STAFF REPORT  
July 2, 2019

**AGENDA ITEM (File No. SPAR-19004)**

Consideration of a Site Plan and Architectural Review application for the installation of two (2) 1,794 square foot modular classroom buildings. The 7.8 acre site is within the Residential Single Family (R-1-6) zoning district and is identified on the Jackson County Assessor's Map as 37S 2W 11B Tax Lot 6700.

**MODULAR CLASSROOM INSTALLATION**  
Job No. 19-018  
05/29/2019

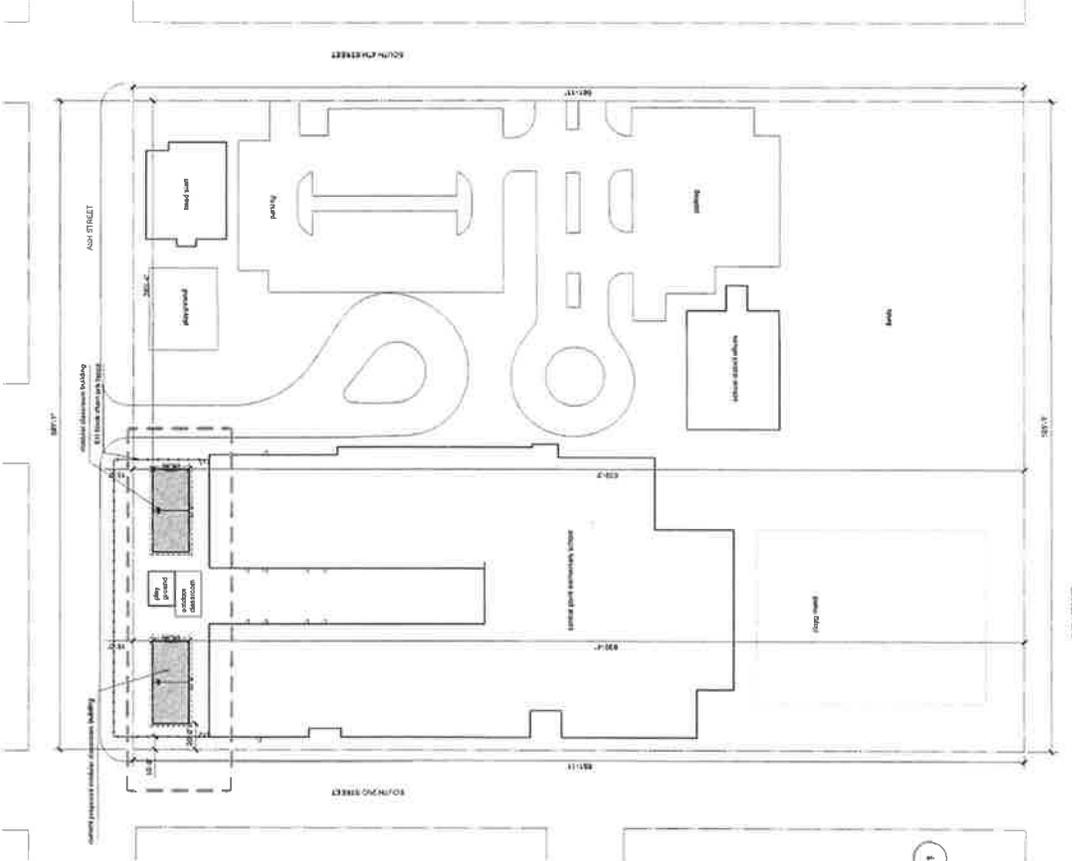
1. **Fencing:** The development proposal includes a six (6) foot tall chain link fence that contains the new development. The fence is proposed along the sidewalk of Ash Street and extends beyond the property line. Galvanized chain link fence is not a permitted fence material in this location.

2. **Stormwater Management:** The project is within the Phase 2 stormwater quality area. All development that proposes 2,500 square feet or more of impervious surface requires a stormwater management plan that is in accordance with the Rogue Valley Stormwater Quality Design Manual (RVSQDM). An operations and maintenance agreement for all new stormwater quality features is required. Construction on site must be sequenced so that the permanent stormwater quality features are installed and operational when stormwater runoff enters.

**Comment:** Staff recommends Condition of Approval No. 1(a) requiring the applicant to submit a revised site plan that depicts the location of the fence along the property line and Condition of Approval No. 1(b) requiring fence designs that demonstrate the fence will be coated or painted consistent with the approved site plan.

**Comment:** Staff recommends Condition of Approval No. 2 requiring the applicant to submit a stormwater management plan and will require a stormwater management plan to the Public Works Department.

1. Demonstrate compliance with the following fence construction standards:
  - a. Submit a revised site plan that depicts the proposed fence on the property line.
  - b. Submit fence designs demonstrating compliance with the site plan for a painted or powder-coated fence material.
2. Submit a stormwater management plan demonstrating compliance with the MS4 Phase II stormwater quality standards to the Public Works Department for review and approval.
3. Demonstrate compliance with the following conditions listed in the Rogue Valley Sewer Services Staff Report (Attachment "C"):
  - a. Submit architectural/plumbing plans for the calculation of related System Development Charges.
  - b. Obtain a sewer service permit from RVSS. This permit will be issued by RVSS upon submittal of appropriate plans and payment of appropriate fees.
